Landpro Reference: 20012

Council Reference: APP-20202268

**Re: Request for Further Information under Section 92(1) of the Resource Management Act 1991 –
Application for Longford Bridge Shared Pathway.**

Figure 1: Abutment shelf and beam soffit levels

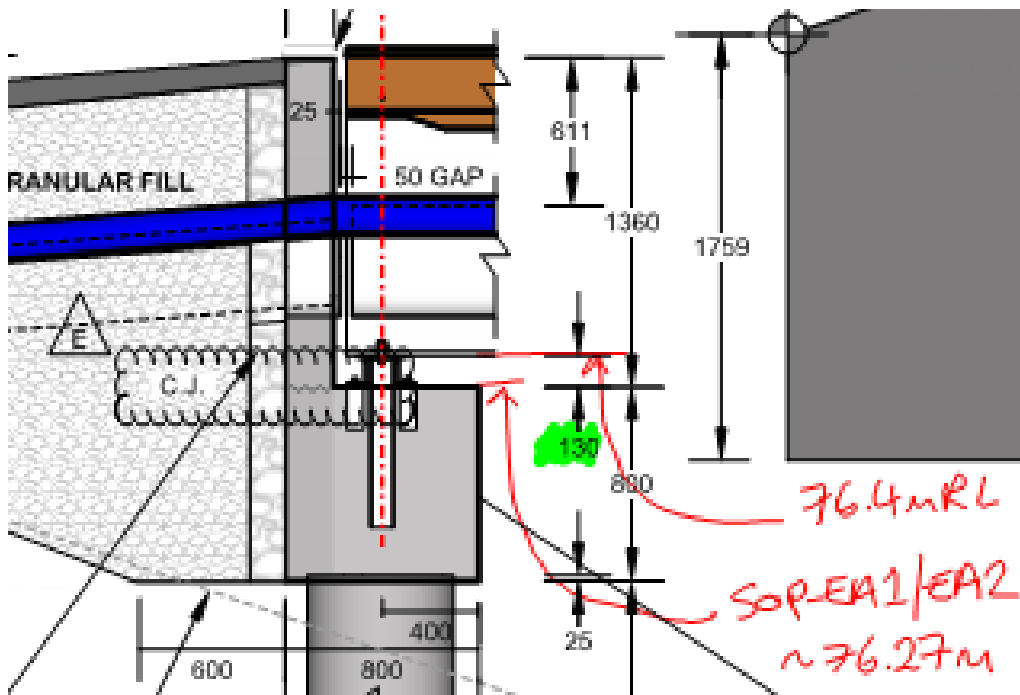
"Confirmation of the eastern abutment construction level. The design diagram shows the soffit at a level of 76.4m (plan S101), but the abutment set out plan shows a level 76.269m (SOP-EA1) plan S111. I am requesting this information because Council's Engineer has some concerns relating to the inconsistent construction levels of the eastern abutment."

The abutment shelf level on S111 is not the same thing as the beam soffit level as shown on S101. Between these two levels is the abutment bearing of circa 130mm (see Figure 1 below). This is not an inconsistency.
